AQUIND INTERCONNECTOR

Day Lane Technical Note

Document Ref: 7.9.29

Aquind Interconnector - Revised HGV Construction Management Strategy for Day Lane

DRAWING NO: AQR-WSP-UK-OS-DR-Z-200215

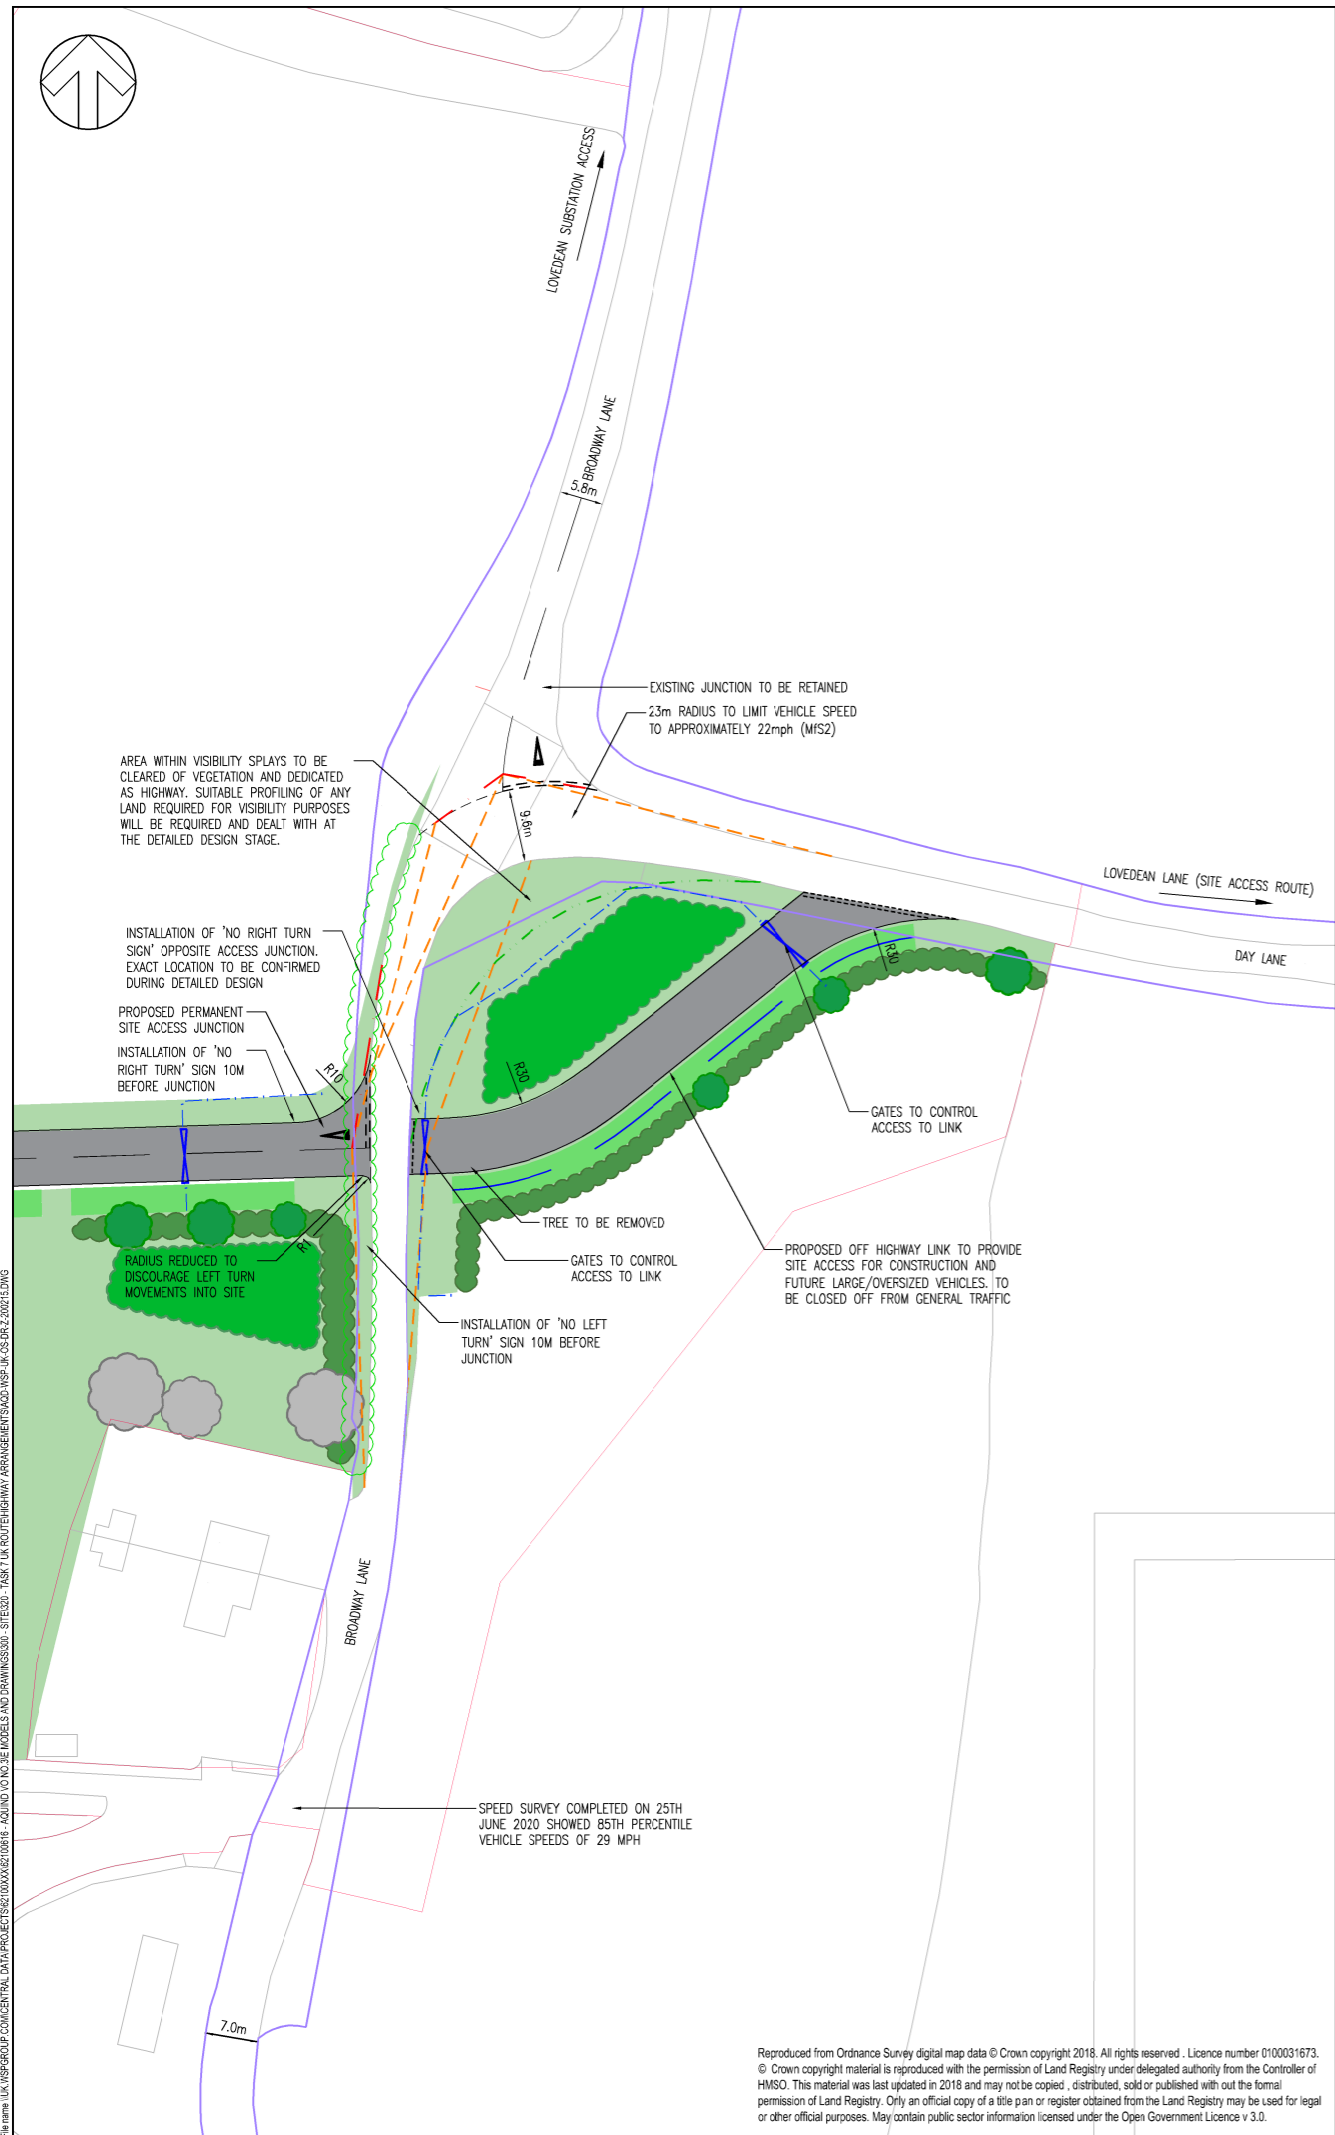
- 2.1.8. Lack of detail regarding finished levels of the area which is currently an agricultural field could lead to a potential increased risk of side impact and nose to tail shunt type collisions occurring, whereby vehicle occupants could sustain personal injury.

- 2.3.1. The Broadway Lane north bound approach to the Converter Station access road junction (Drawing No. AQD-WSP-UK-OS-DR-Z-200215 Rev 04).

Summary - Lack of detail regarding finished levels of the area which is currently an agricultural field could lead to a potential increased risk of side impact and nose to tail shunt type collisions occurring, whereby vehicle occupants could sustain personal injury.

Location 4 - The Broadway Lane north bound approach to the Converter Station access road junction (Drawing No. AQD-WSP-UK-OS-DR-Z-200215 Rev 04).

- 2.1.11. Problem accepted. Suitable profiling of any land required for visibility purposes will be required and dealt with at the detailed design stage. A note to this effect has been added to drawing AQD-WSP-UK-OS-DR-Z-200215 included in Appendix C.

- 2.3.4. Problem accepted. Signage indicating No Left Turning can be provided for, enforced by a Traffic Regulation Order which can be included for within the dDCO. Details of the location of the No Left Turning sign are shown on drawing AQD-WSP-UK-OS-DR-Z-200215 included in Appendix C.

DRAWING No: **AQ-UK-DCO-TR-LAY-008** REV: **C**

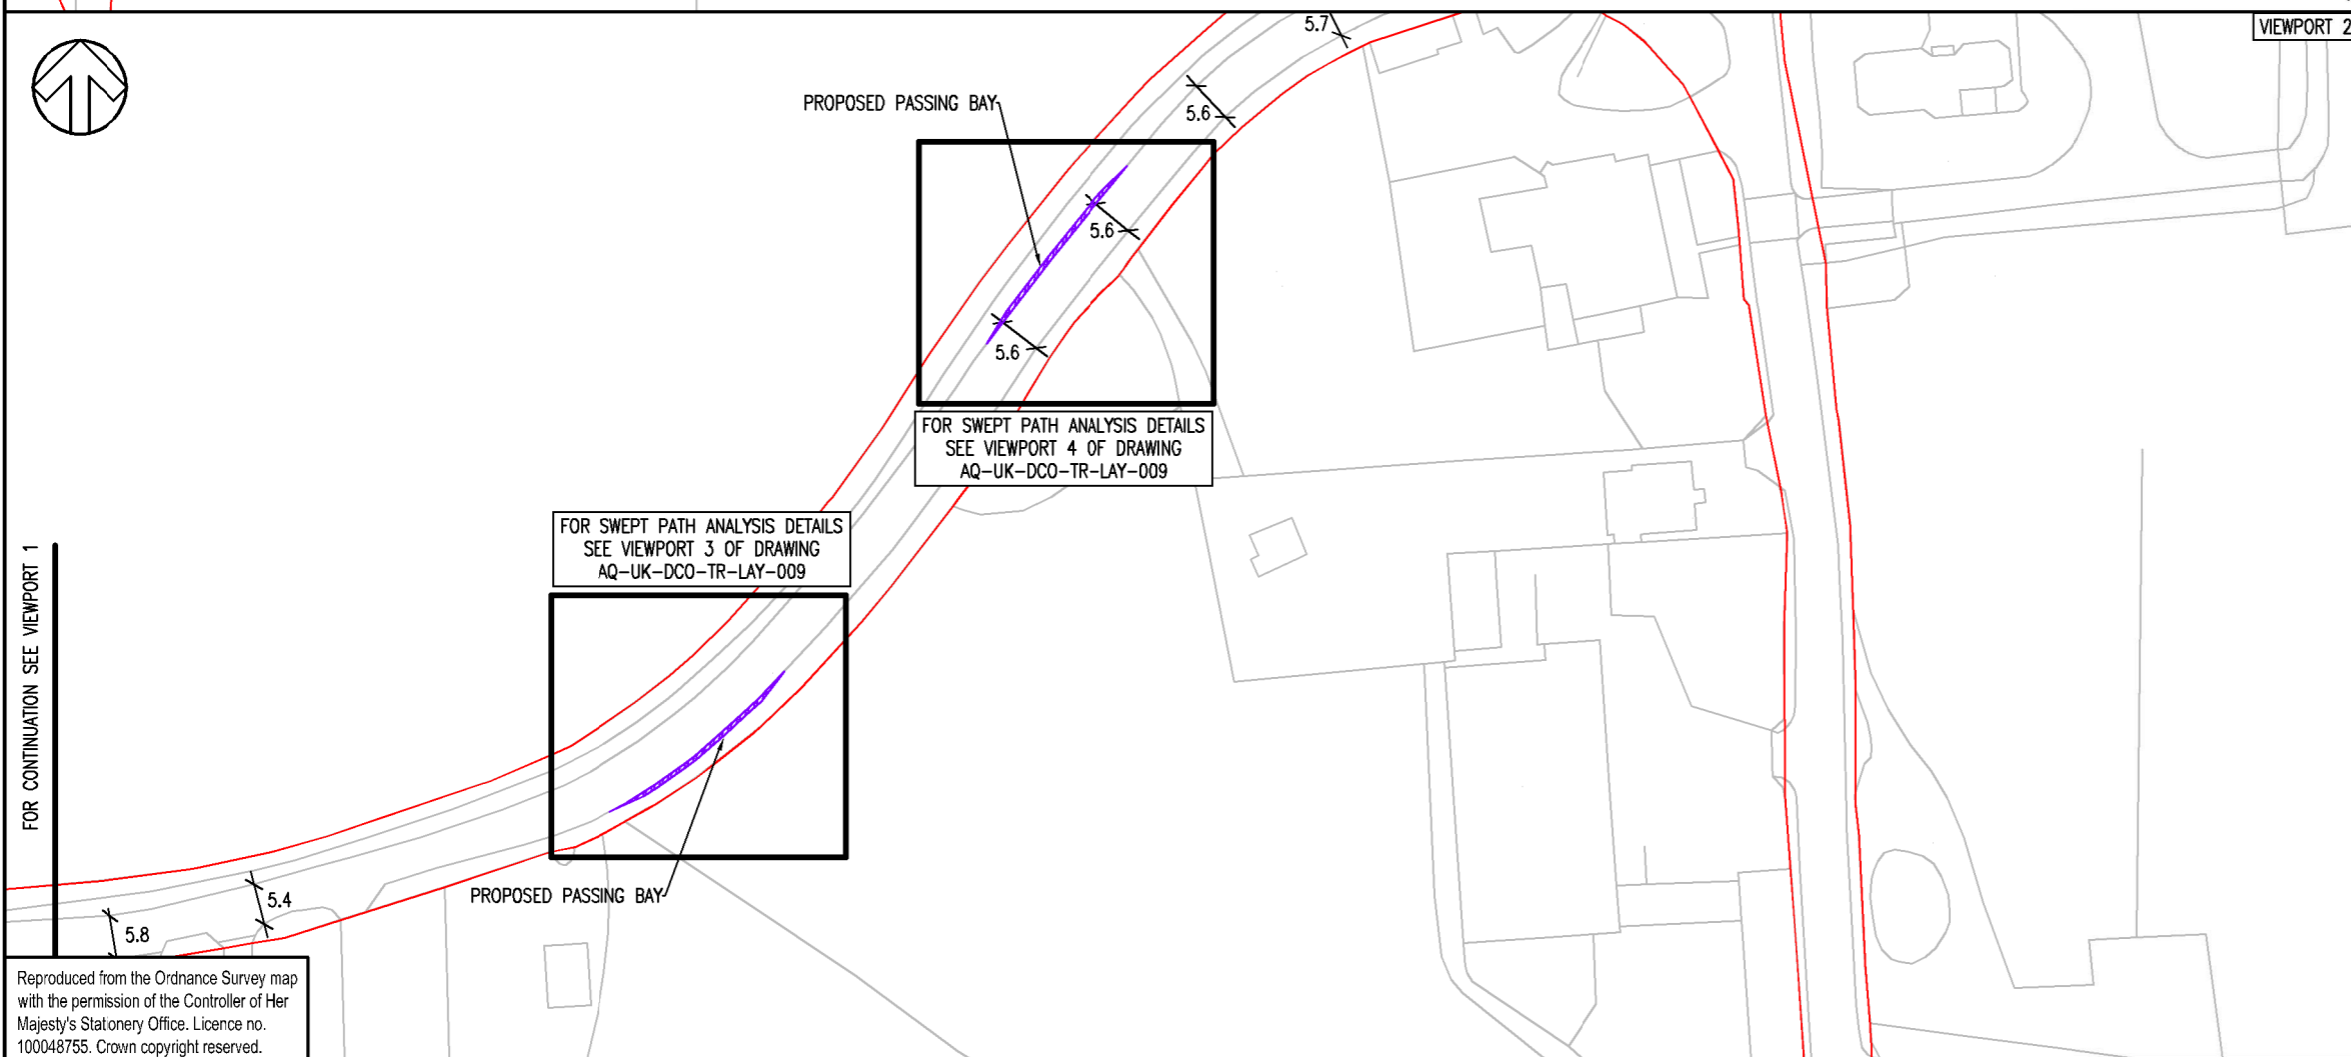
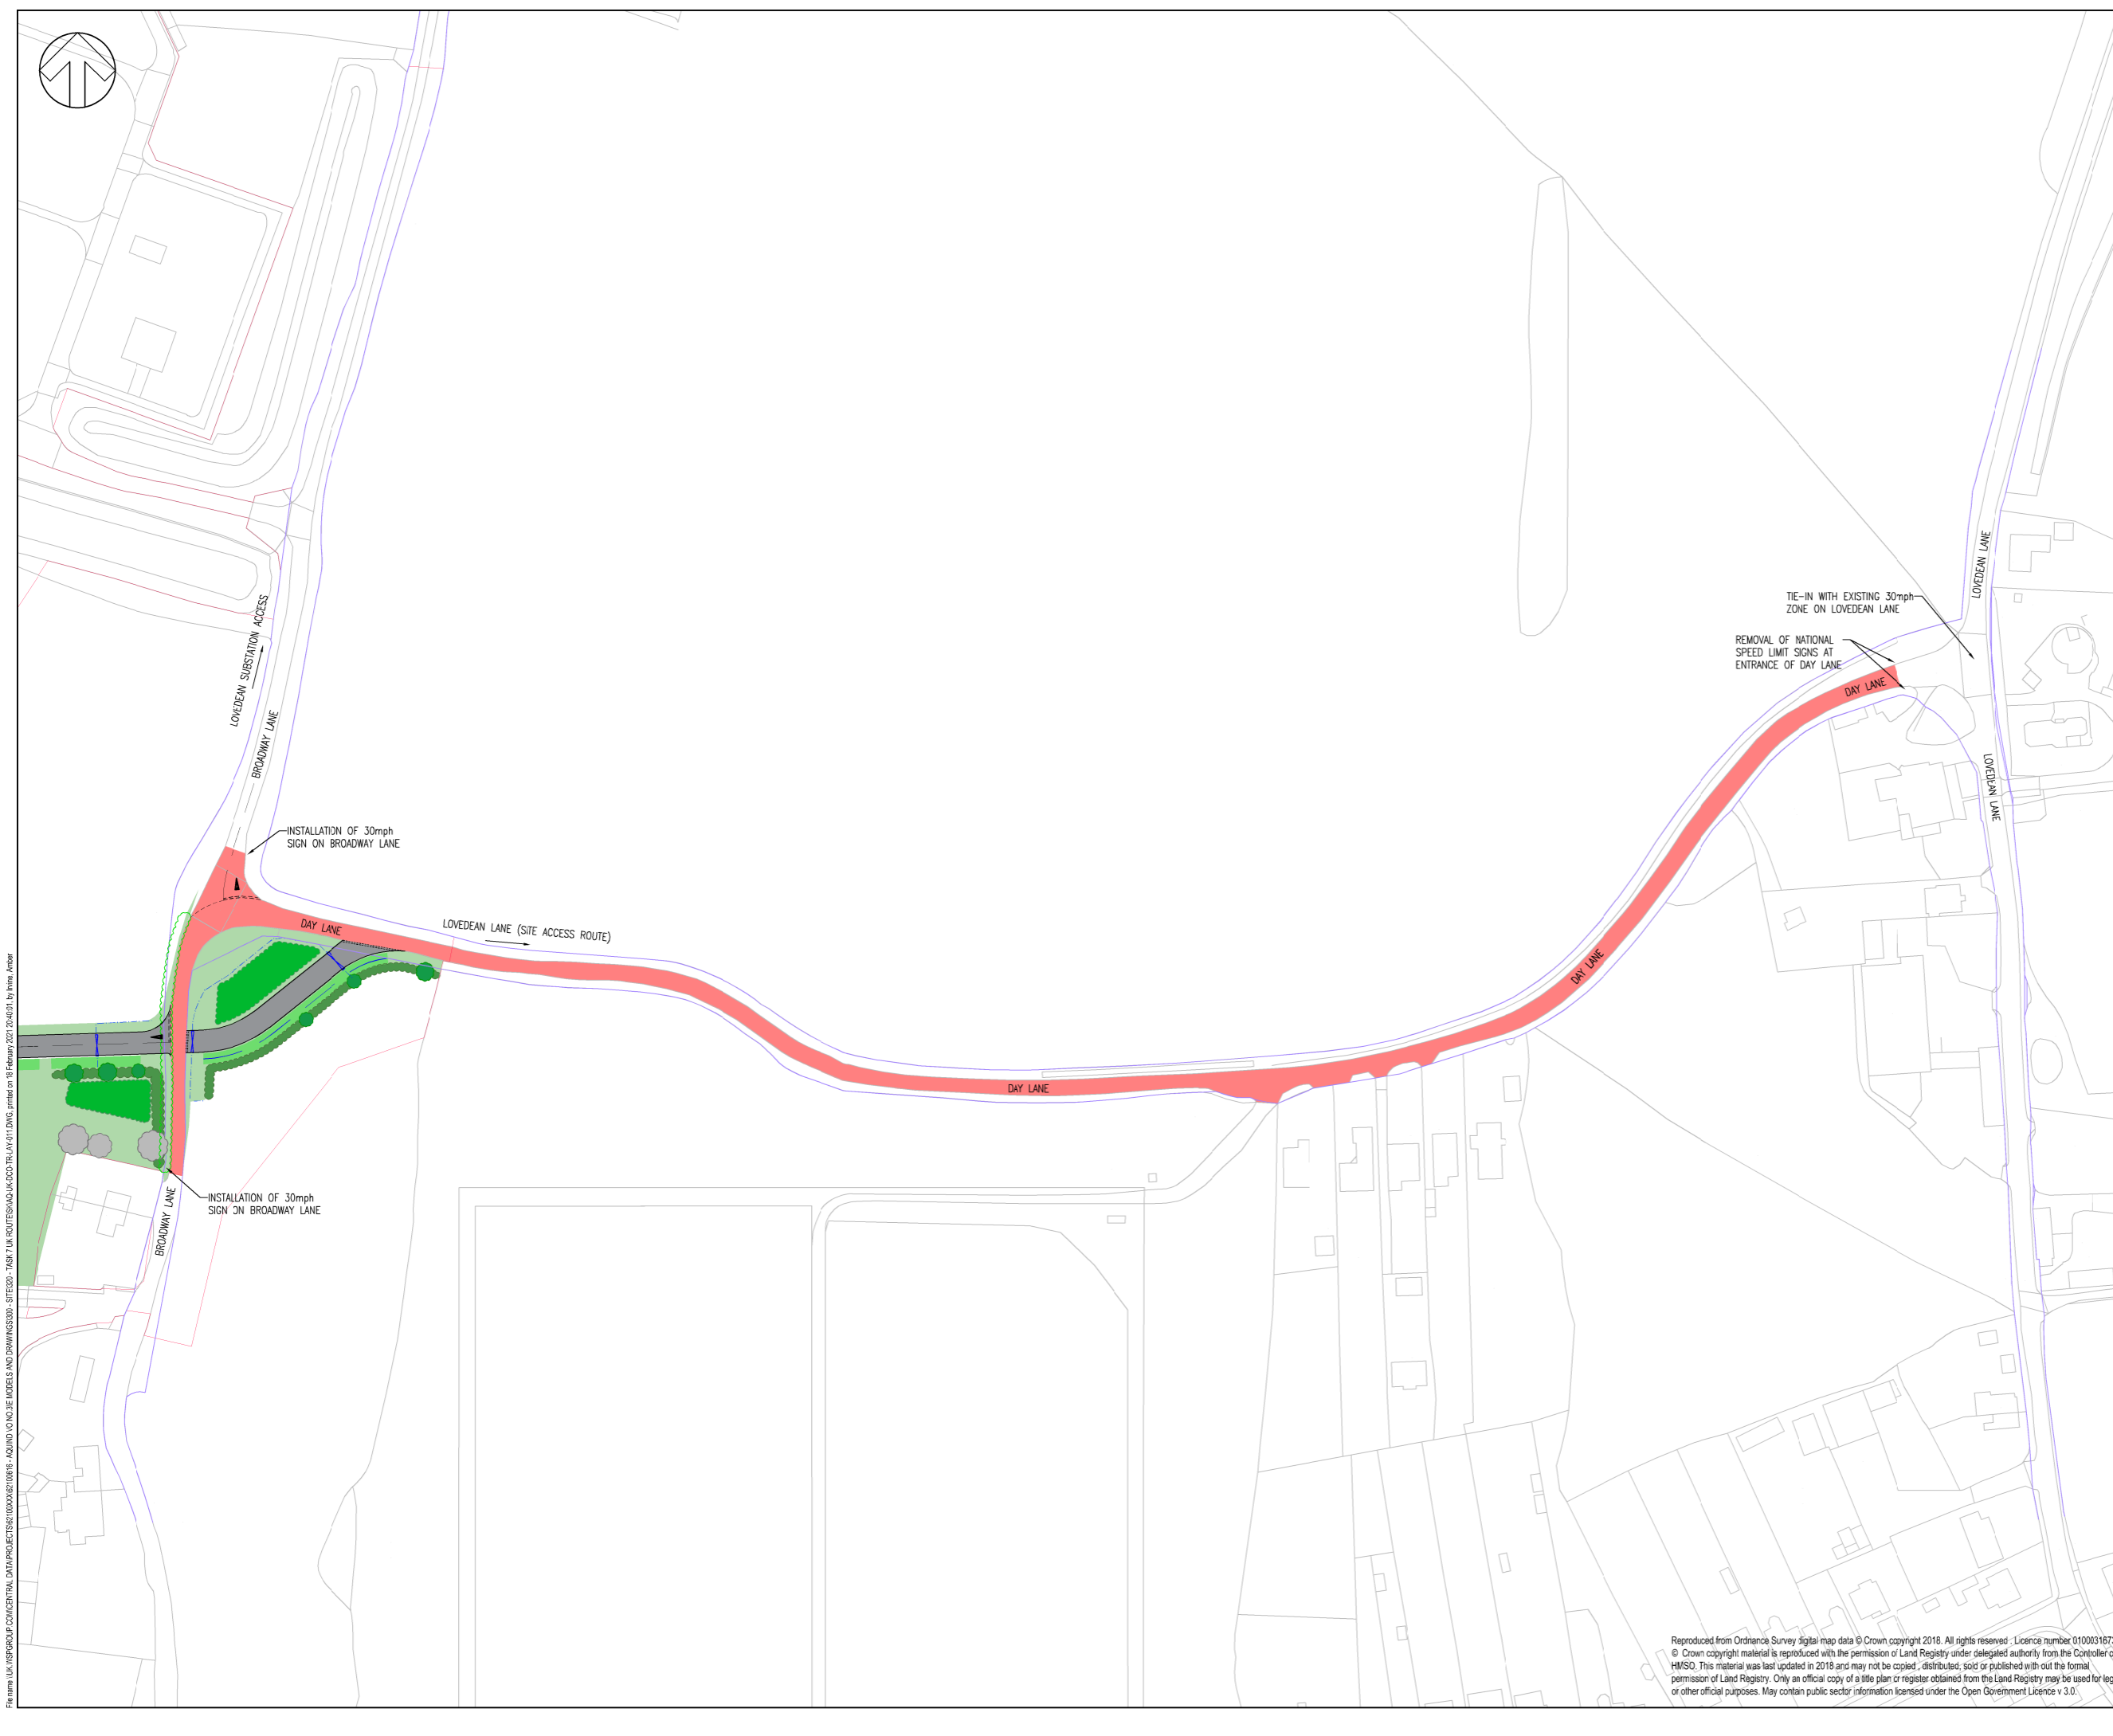
2.6.1. It has been agreed with the Highway Authority that the final arrangements of the Day Lane passing bays (shown on Drawing AQ-UK-DCO-TR-LAY-008 included in Appendix C) can be confirmed at the detailed design stage, albeit that the works to be delivered must be capable of allowing a car and an HGV to pass satisfactorily. This may necessitate that widening be provided on both sides of Day Lane in order to avoid any implications on tree and hedgerow root protection zones.
